## Minnesota Pollution Control Agency

Enclosed for your review is the Minnesota Pollution Control Agency's (MPCA) proposed revisions to the General Mills Remedial Action Plan submitted to the MPCA on April 11, 1984. I anticipate that our meeting on May 7, 1984 will focus on General Mills' comments regarding MPCA's proposed Consent Order mailed to you on March 23, 1984 and on MPCA's proposed revisions to the General Mills Remedial Action Plan.

EXHIBIT A  
REMEDIAL ACTION PLAN

GLACIAL DRIFT SAMPLING WELLS

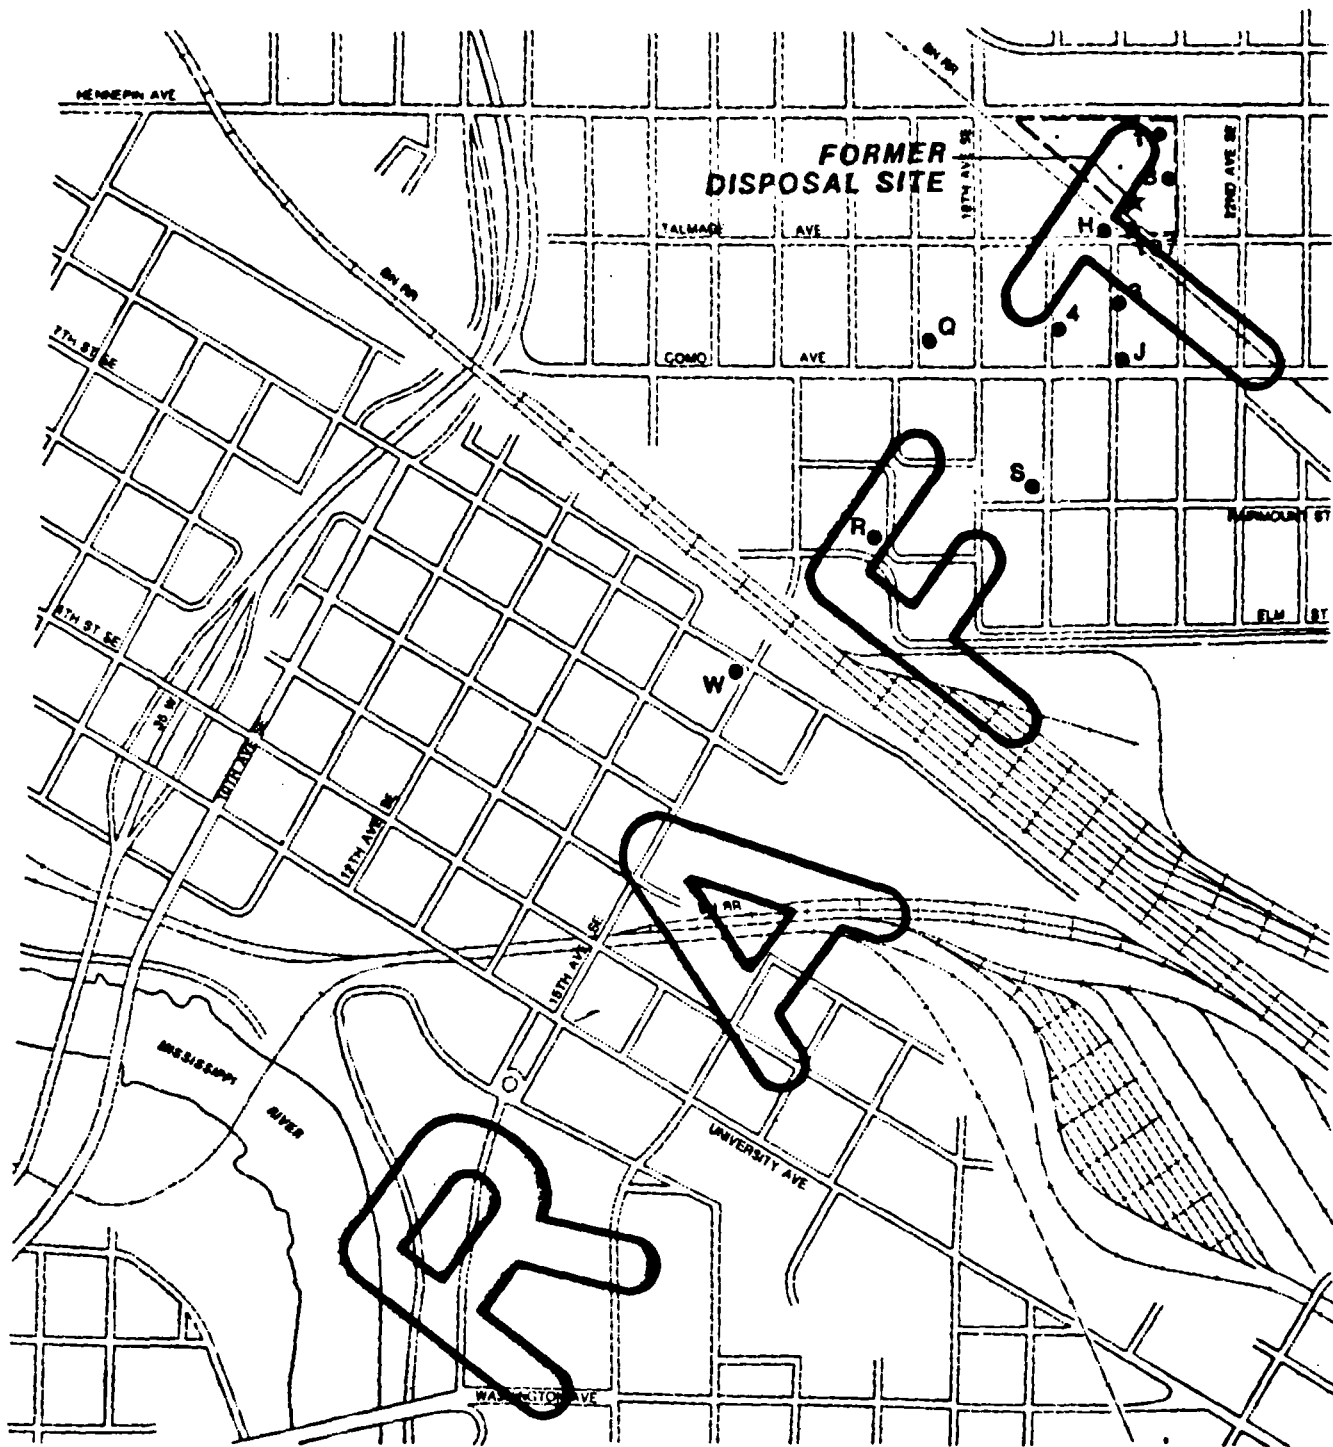
\* Add glacial drift pump out wells, T, U, V, X, Y, and Z to the map.
